PROPOSED IMPROVEMENT
BRIDGE PROJECT
TOWN OF BERKSHIRE
COUNTY OF FRANKLIN
VT. ROUTE 118 - MAJOR COLLECTOR
BRIDGE NO. 30

RECORD PLANS

PROJECT NAME:	BERKSHIRE		
PROJECT NUMBER:	BHF 0283(9)S		
FILE NAME:	SC304IND2.XLS	PLOT DATE:	4/2/09
PROJECT LEADER:	R. HEBERT	DRAWN BY:	S. MORGAN
DESIGNED BY:	R. HEBERT	CHECKED BY:	R. HEBERT
INDEX OF SHEETS	SHEET 2	OF	41

FRT ELEV VIEW ~ OB8-OB11, OB15-OB18

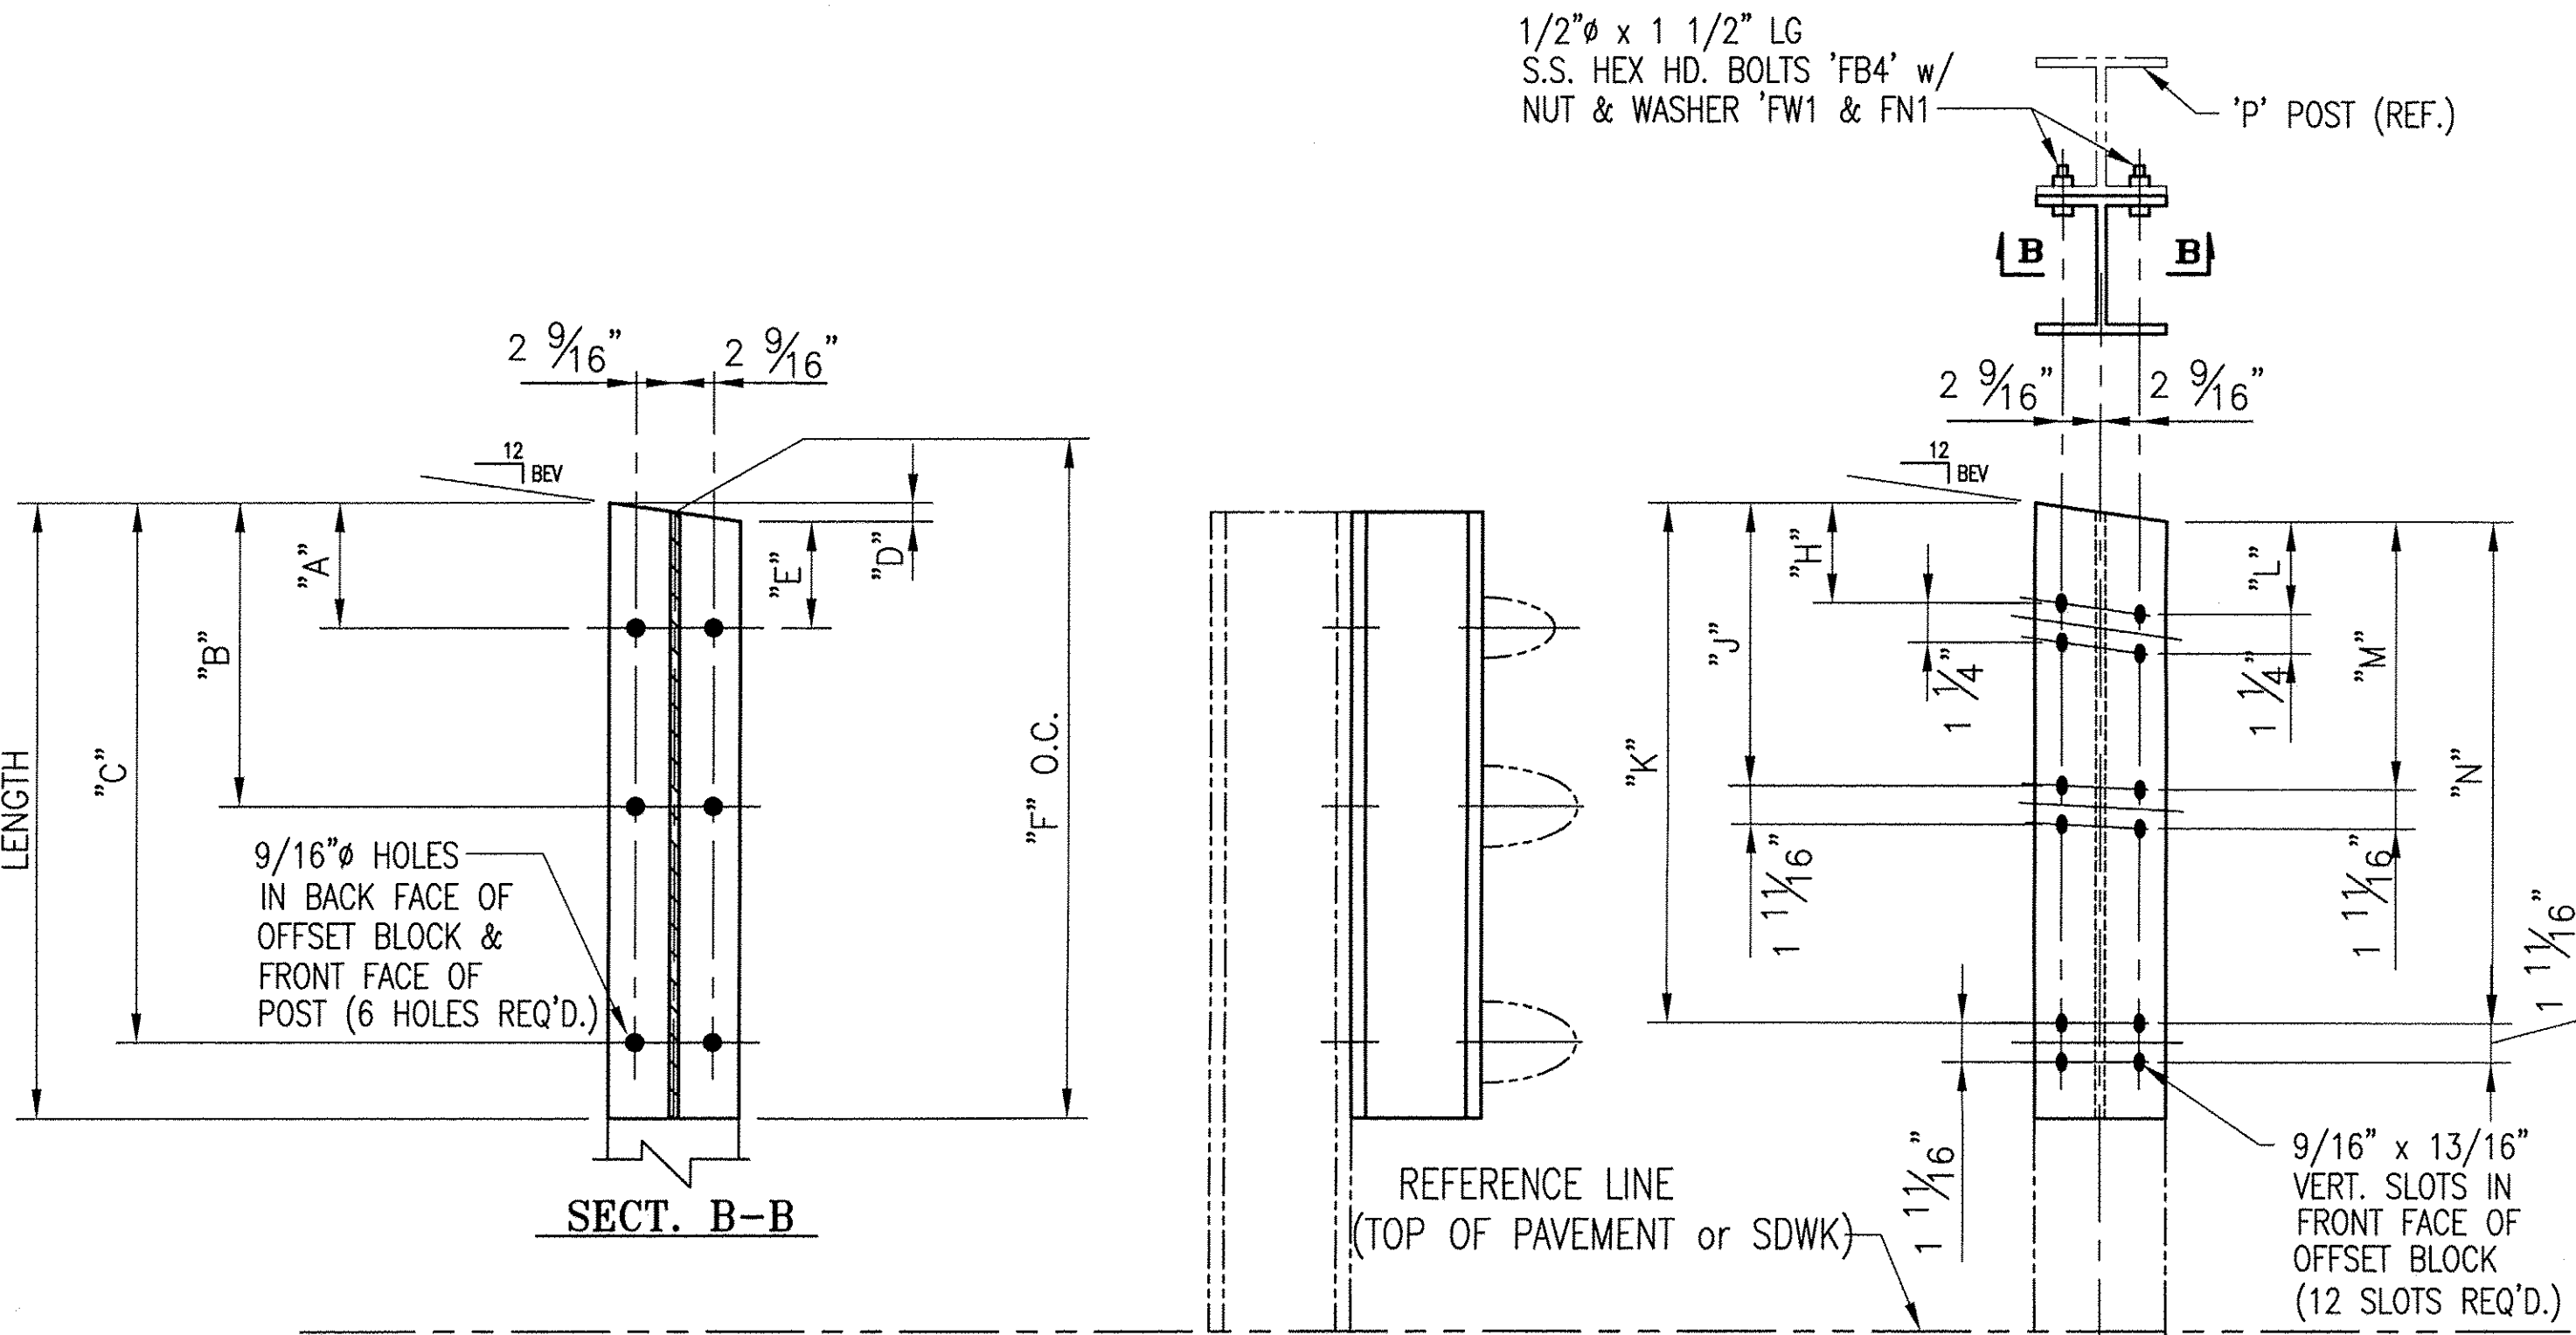
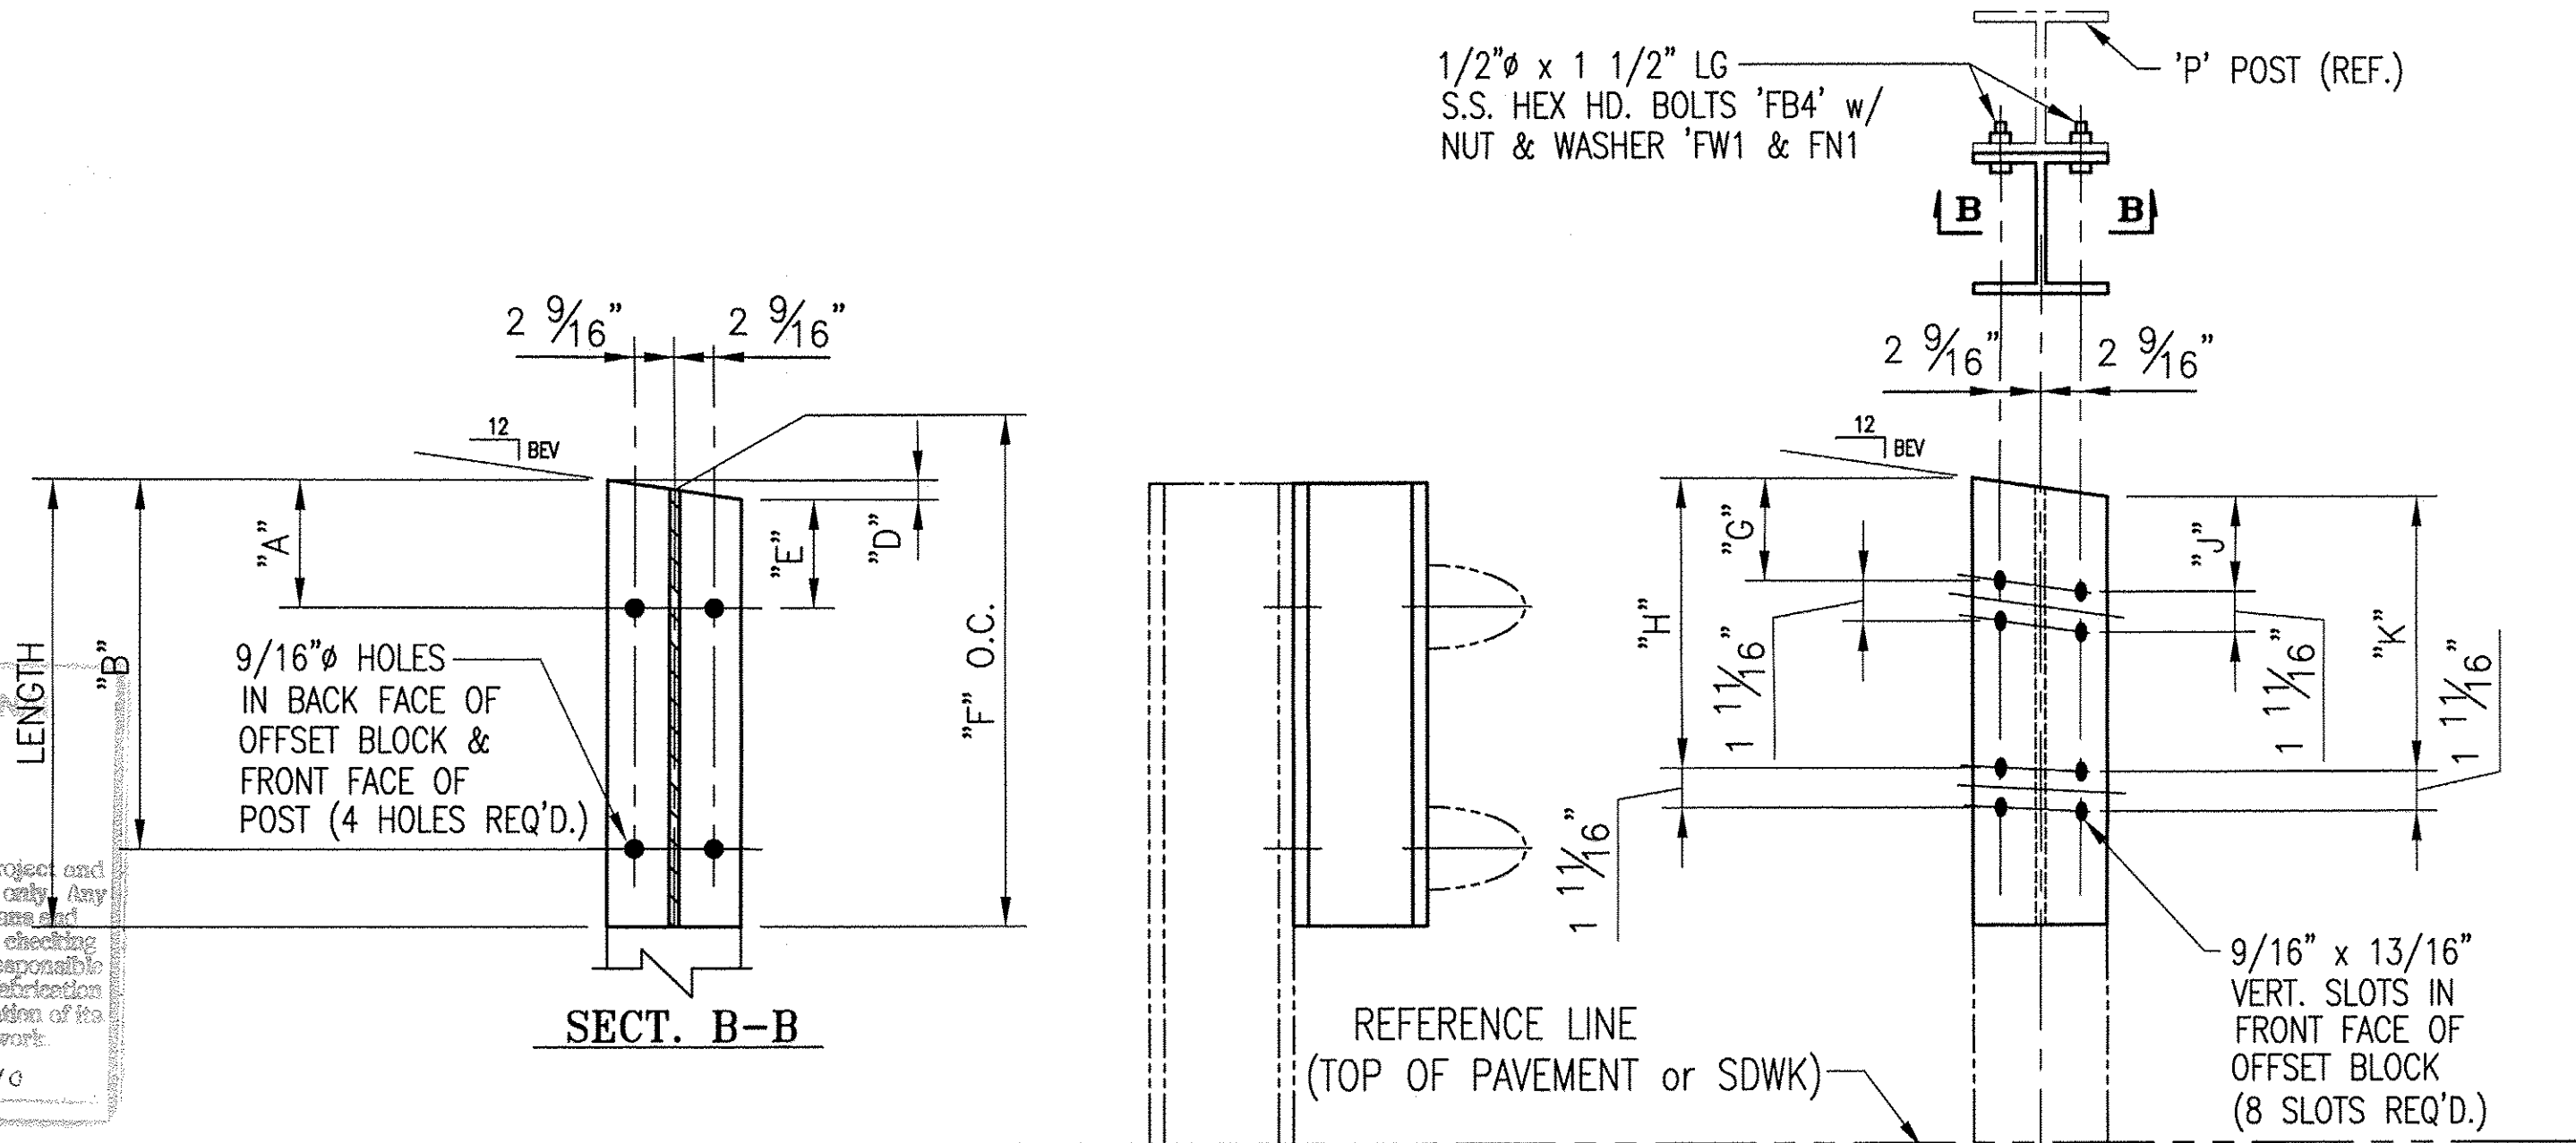
REV.	DESCRIPTION	BY	DATE
1	REVISED DIMENSIONS PER APPROVERS MARKUPS	CMS	03/23/10

DETAIL "B"
 (FRONT ELEVATION VIEW)

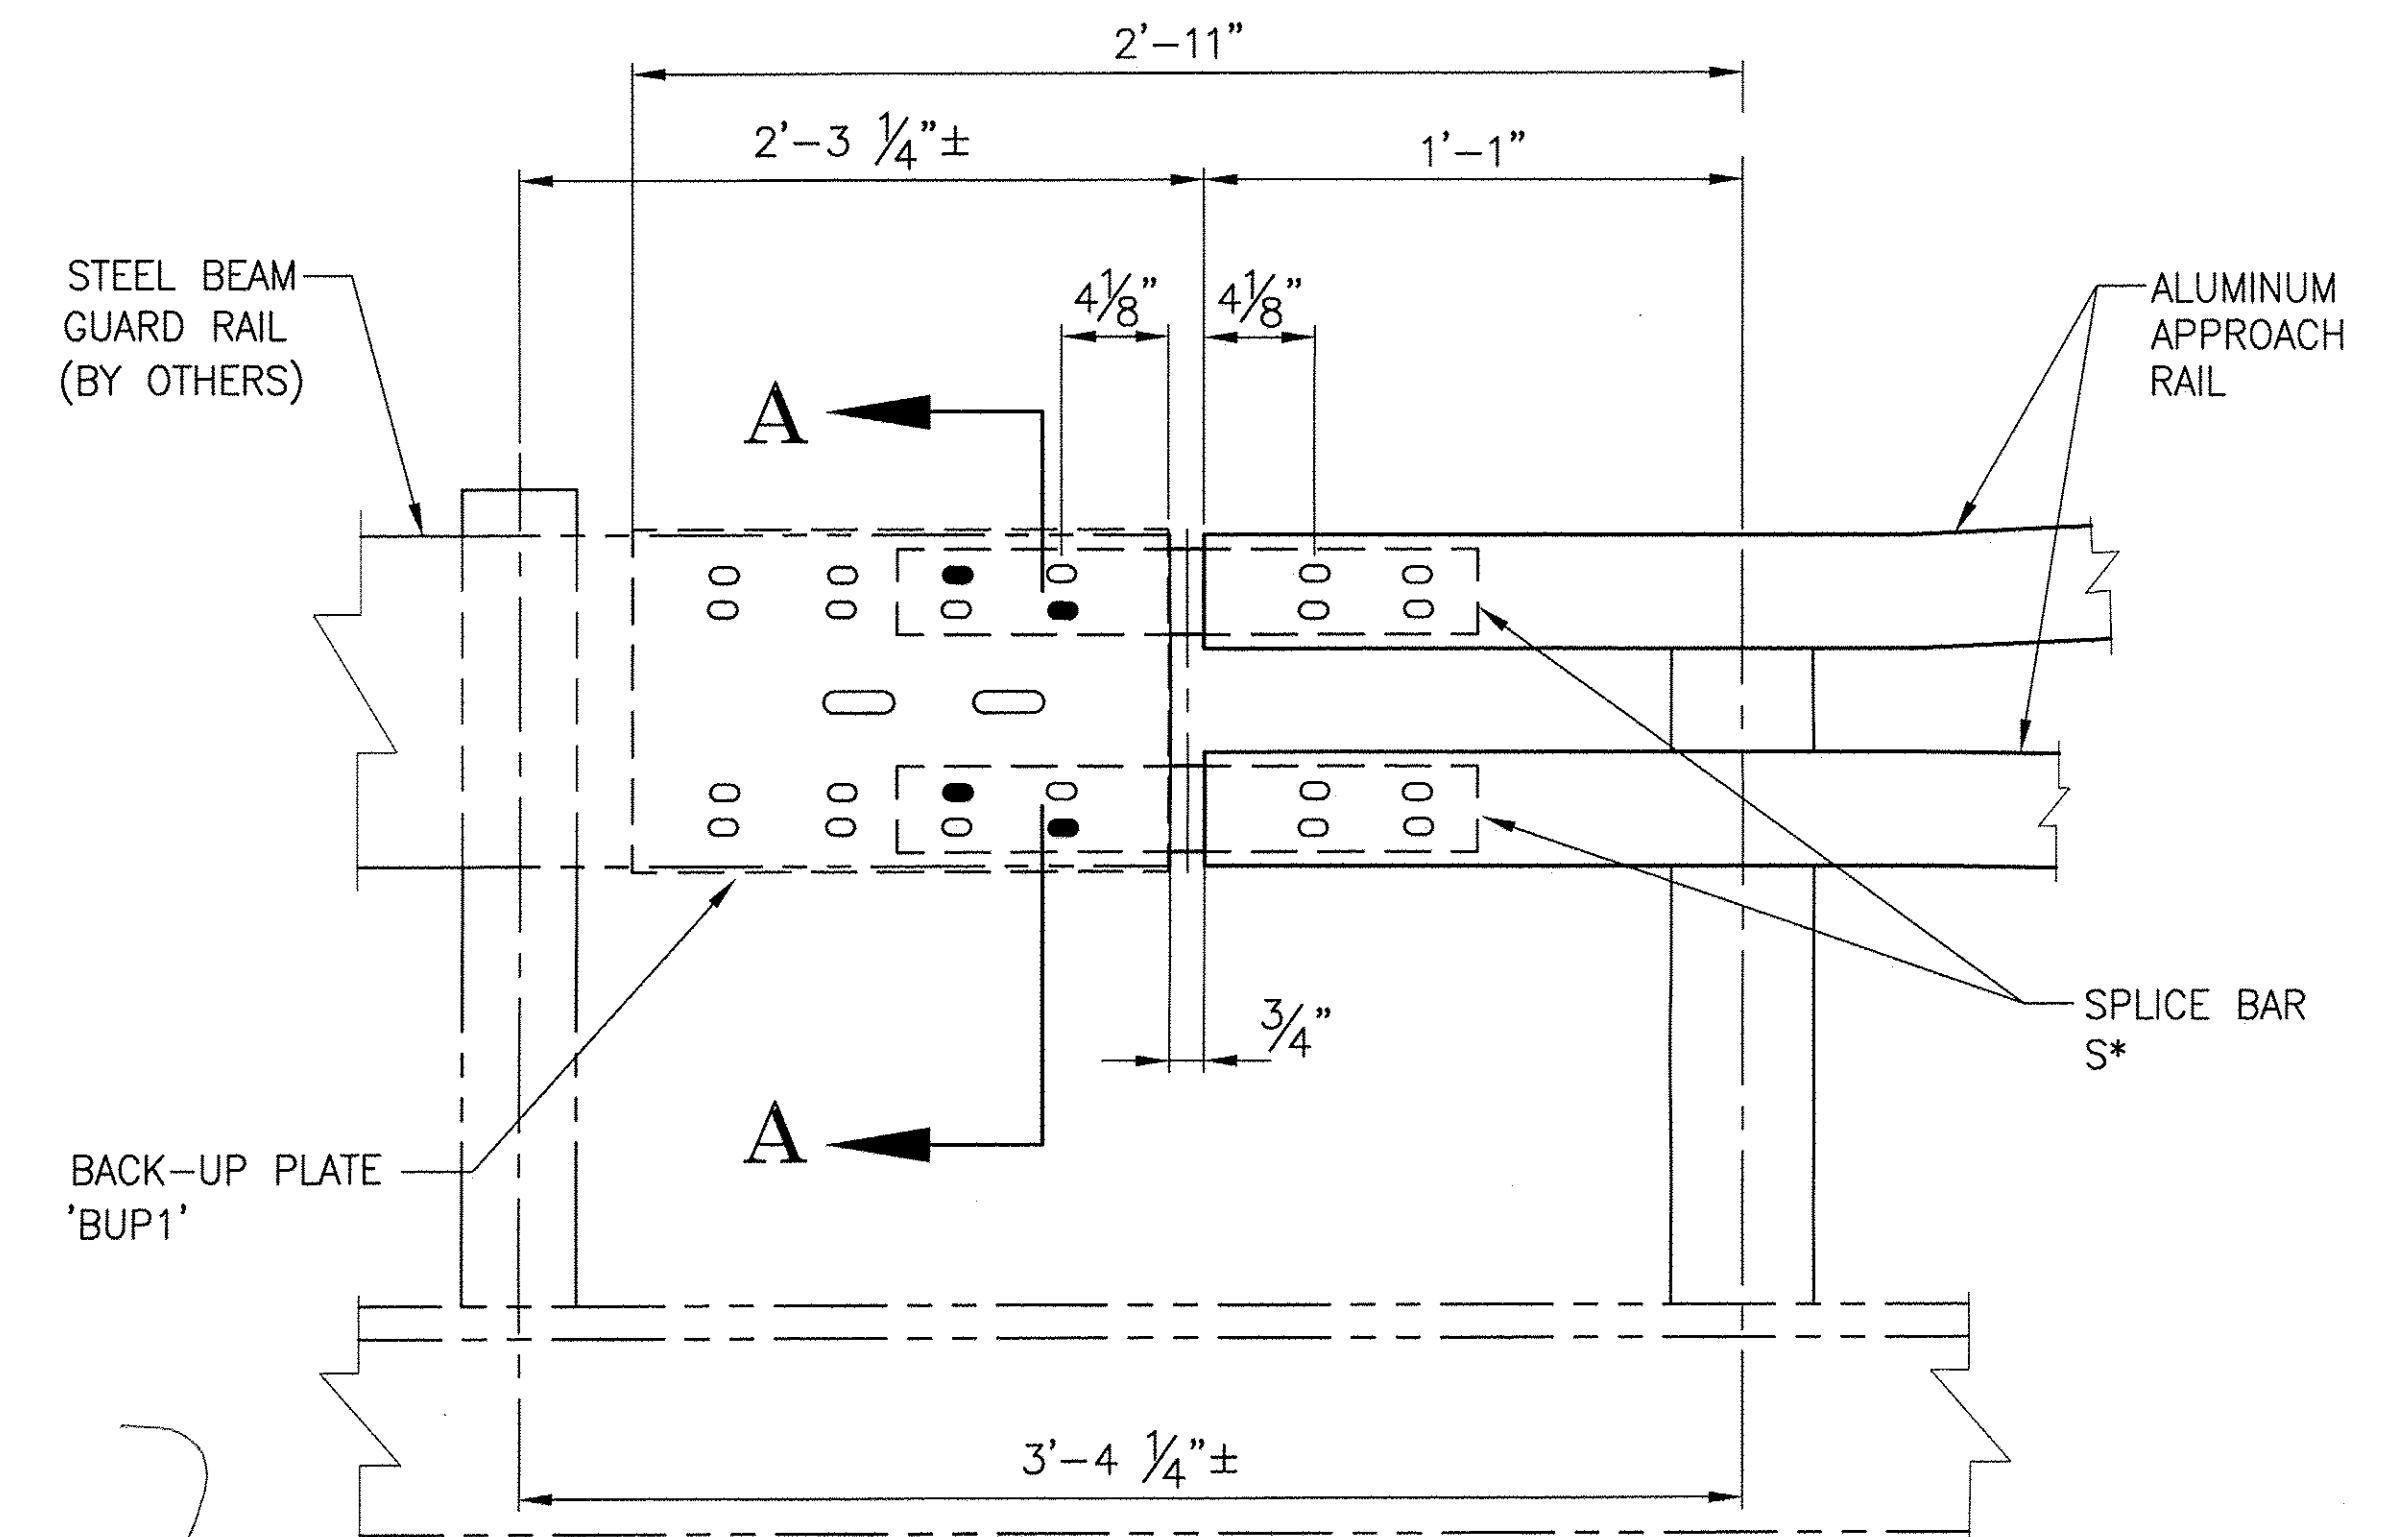
APPROVER,,
 THERE APPEARS TO BE A DIMENSIONAL
 PROBLEM WITH THE STATE STD. DWGS ON THE
 SIDE AT THE RAIL SPLICE. THE 4 5/8" WOULD
 EXTEND THE PLATE BEYOND THE CENTERLINE OF
 THE SPLICE TOWARDS THE RAILING.
 PLEASE VERIFY.

Agreed.
